Φ02314

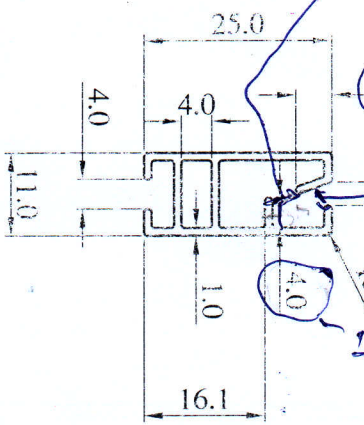
This Gap also is very less.

Depth is too much

Gap 2.7 is very less

Depth is too much.

Please ask customer, what is the end use application & if any matching component is available with customer since profile is very small & very critical.
